SECTION 00 91 13 - ADDENDUM No. 2

December 12, 2024

CITY OF ROCKMART
ROCKMART AMPHITHEATER COMPLEX
219 CHURCH STREET,
ROCKMART, GEORGIA 30153

REVISIONS		CITY OF ROCKMART, GEORGIA	
DECEMBER 2024		HISTORIC ROCKMART EVENT CENTER	
GRADING AND DRAINAGE PLAN			
DRAWN	CHECKED		
SPS	JLR	SCALE: AS SHOWN	DATE: SEPTEMBER 2024
		ATLANTA AUGUSTA ST. SIMONS ISLAND	SHEET C501

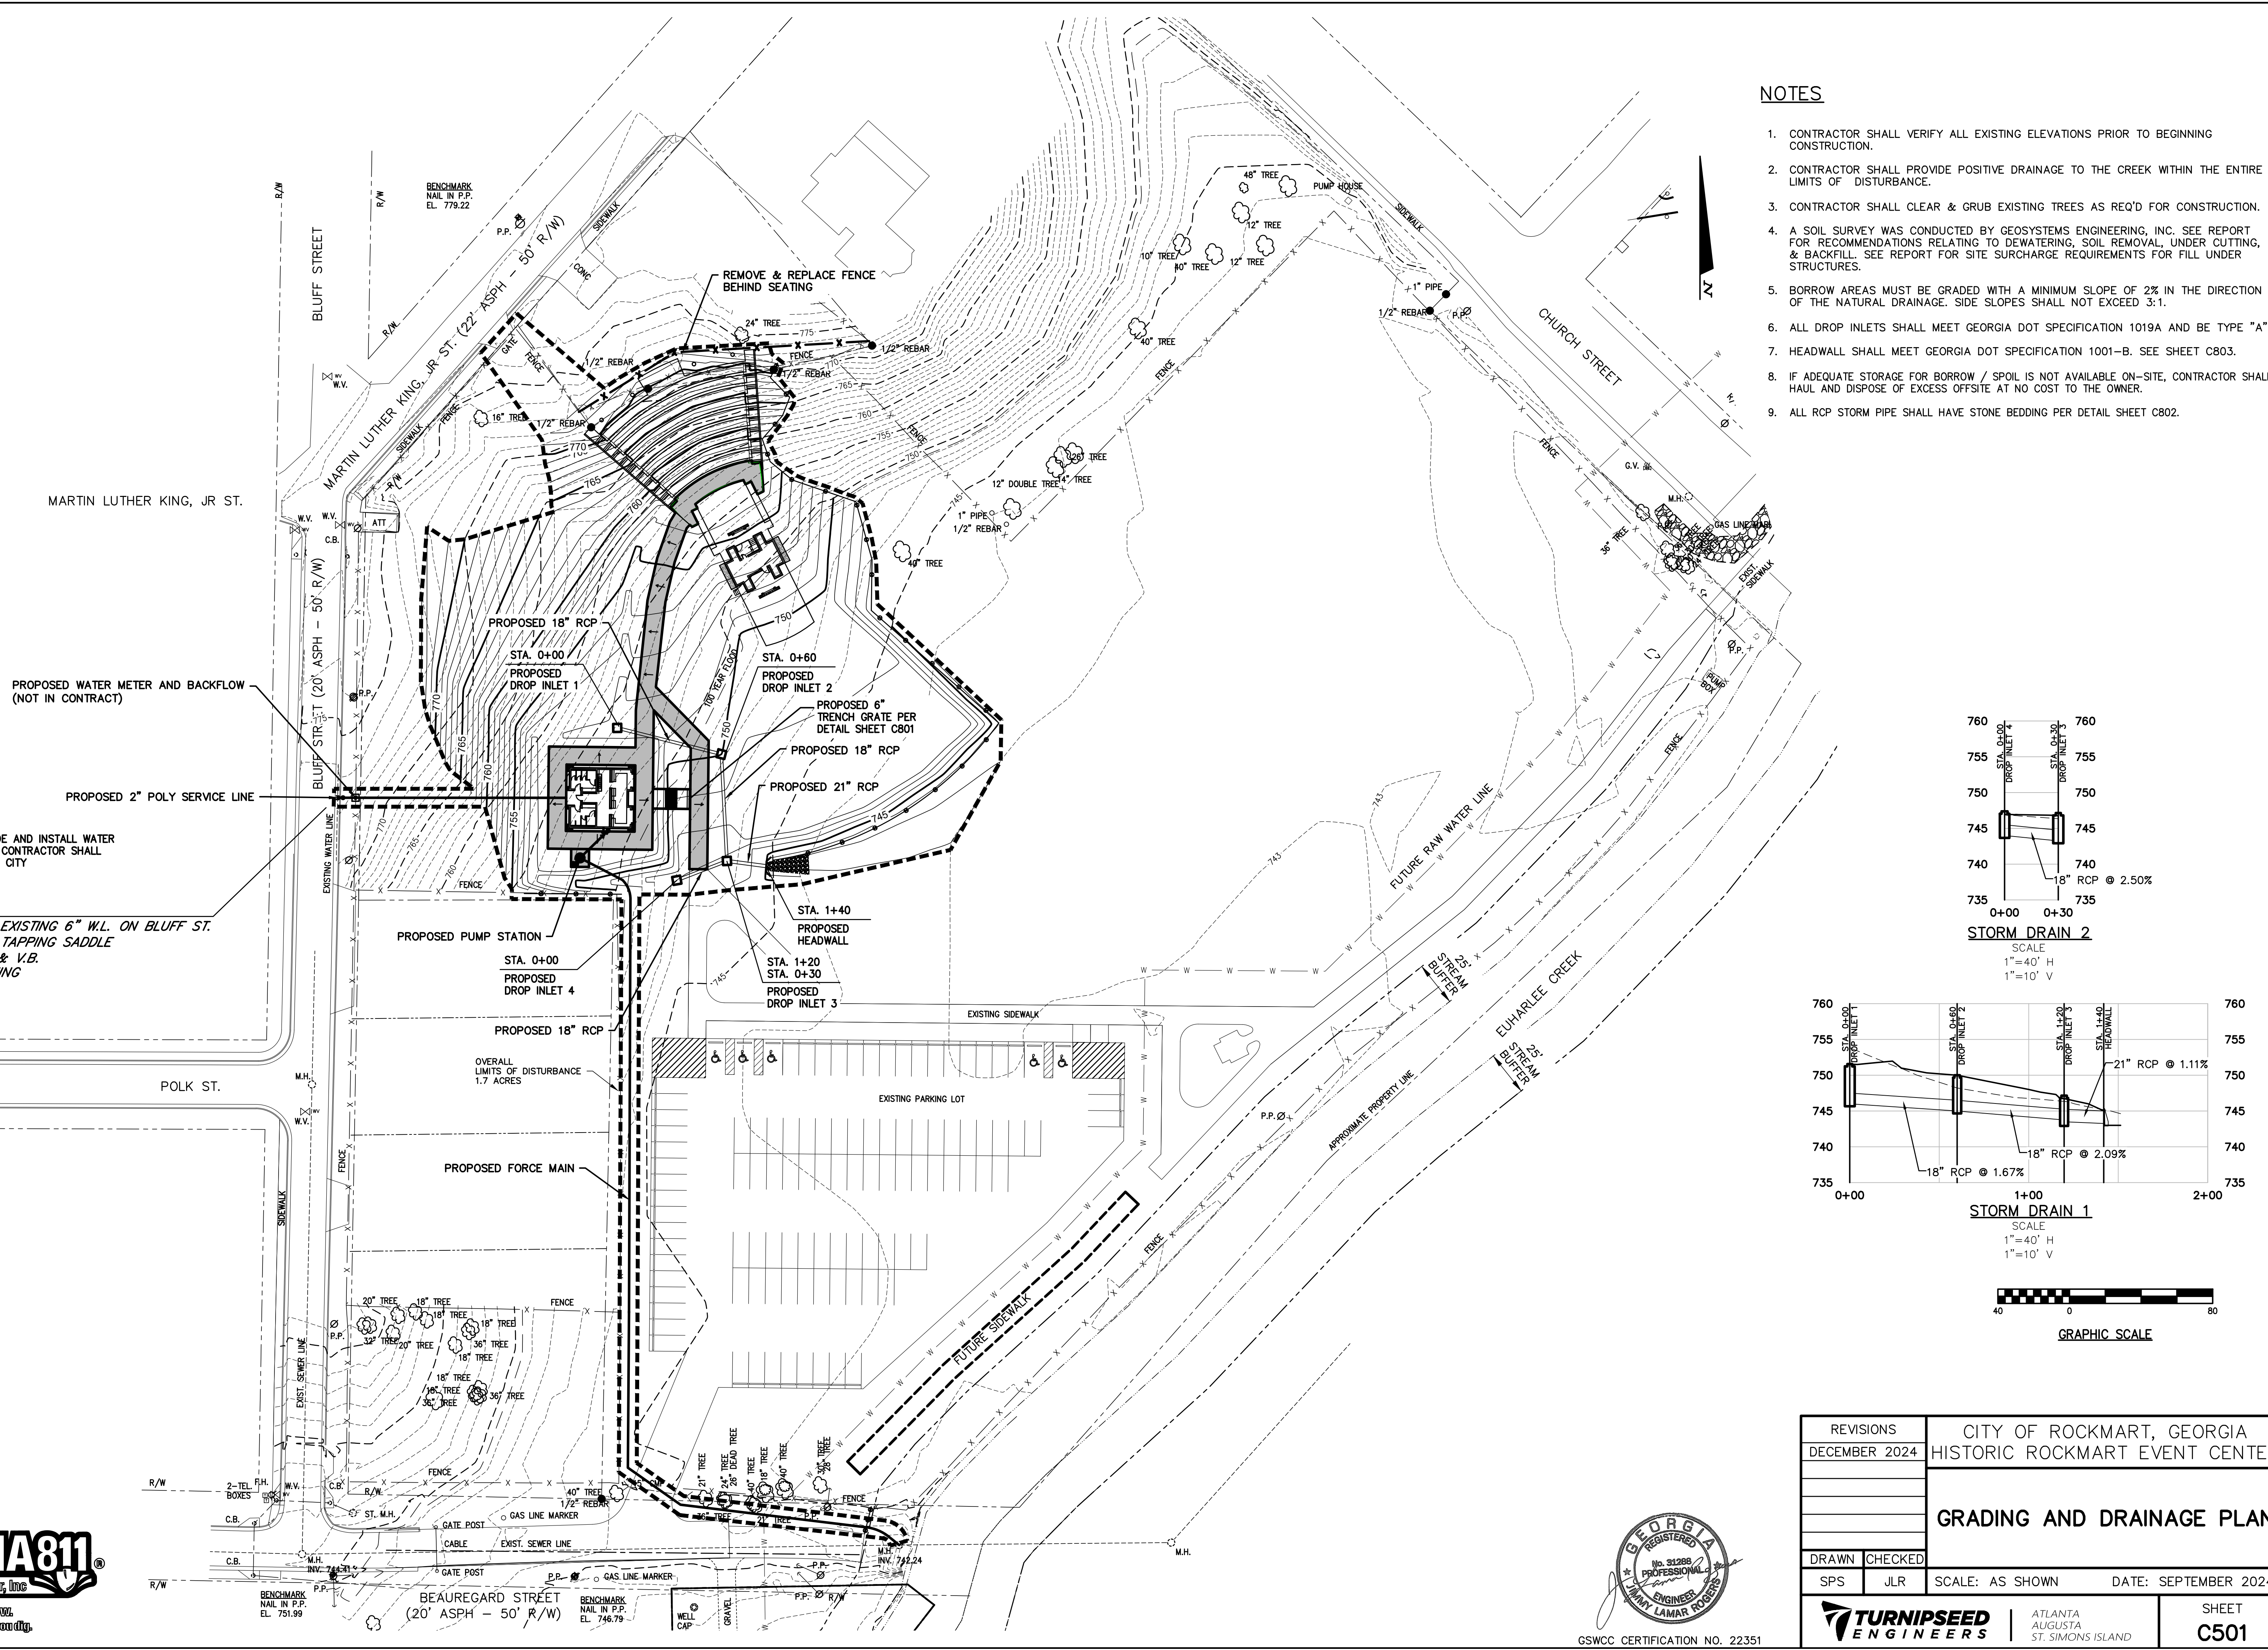
What is the Storm Piping material and size? The Civil Site drawings do not provide any detailed information regarding any material types and or their sizing. **Labels indicating the pipe size and material have been added to attached revised Sheet C501, Grading and Drainage Plan.**

Is the Water Line metered and is there a Backflow in the Concessions building (versus in the site)? Please clarify. **Water meter and Backflow have been added to revised Sheet C501, Grading and Drainage Plan. City will provide and install Water meter and Backflow, Contractor shall coordinate with City during construction.**

Sizes are not shown for the stormwater piping. Please advise. **Labels indicating the pipe size and material have been added to attached revised Sheet C501, Grading and Drainage Plan.**

Could we get some clarification on the size and type of pipes that will be a part of Storm Drain 1 & 2? **Labels indicating the pipe size and material have been added to attached revised Sheet C501, Grading and Drainage Plan.**

NOTE: CITY WILL PROVIDE AND INSTALL WATER METER AND BACKFLOW. CONTRACTOR SHALL COORDINATE WORK WITH CITY
